Appendix B
Comments and Response
January 20, 2011 Draft Presentation

Appendix B: Comments and Response – January 20 Presentation of Draft Results

To: Natelle Dietrich, Missouri PSC; Brenda Wilbers, Missouri DNR
From: Tom Franks, KEMA
Date: February 7, 2011
Copy: Fred Coito, Kristina Kelly, KEMA; Gwen Mizell, GSM
Subject: Response to stakeholder comments – submitted through January 25, 2011

Figure 5-22
Achievable Electric Energy-Savings: All Sectors

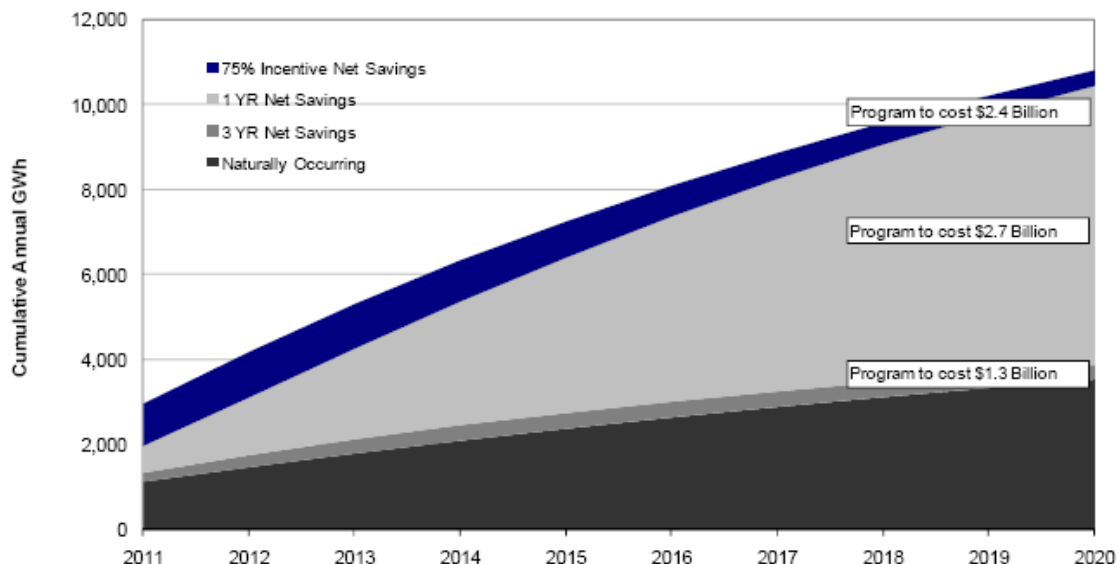
According to Figure 5-22, the impact of naturally occurring energy efficiency estimated by KEMA is significant – very significant.

It is in the 25% to 50% range of total energy efficiency savings depending upon the scenario under consideration.

Figure 5-22 and the level of naturally occurring energy efficiency should raise a multitude of energy efficiency policy issues with the Commission – if the KEMA estimates of naturally occurring energy efficiency are truly indicative of where the energy efficiency market is. If naturally occurring energy efficiency represents 25% to 50% of all achievable energy efficiency potential, that indicates that the market for energy efficiency products and services is significantly, albeit not completely, transformed. According to Figure 5-22, it appears that utility sponsored DSM programs that KEMA projects to cost \$1.3 billion over ten years will only add a miniscule increment to the overall levels of energy efficiency savings in the state.

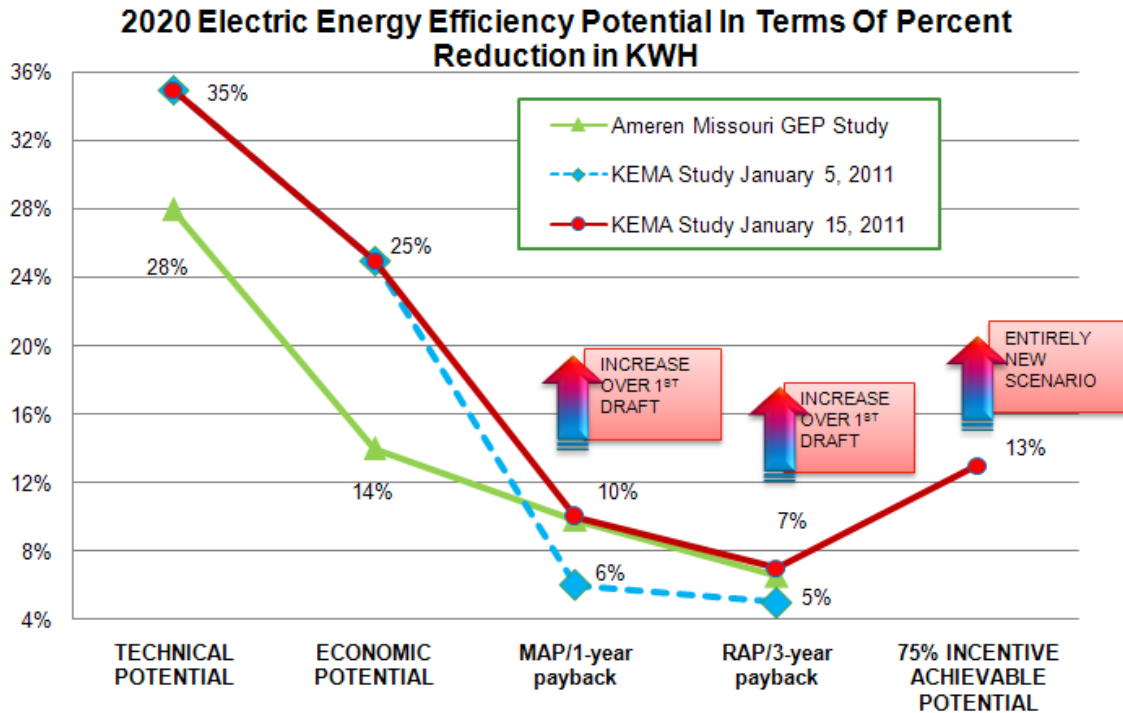
The following graph illustrates the significant differences in estimates of both technical and economic potential between the Ameren Missouri electric DSM potential study and the KEMA statewide electric portion of the DSM potential study. The differences are problematic because there are succinct, quantitative methods to estimate technical and economic potential. Two studies completed within 12 months of each other in the same state should produce much closer estimates. Estimating achievable potential, in contrast, involves a high degree of subjectivity if estimates are not based on primary market research. The achievable estimates derived by KEMA, based on penetration/adoption curves, have not been described or documented in detail at the measure level in any way other than a general listing of illustrative curves in Appendix A.

The ultimate type of DSM potential that the KEMA study estimates is achievable potential. Achievable potential is a function of economic potential which is a function of technical potential. Errors in the estimation of technical and economic potential necessarily impact the estimate of achievable potential. The graph illustrates the magnitude of the differences in technical potential (35% vs. 28% - a 25% difference) and in economic potential (25% vs. 14% - a 79% difference).
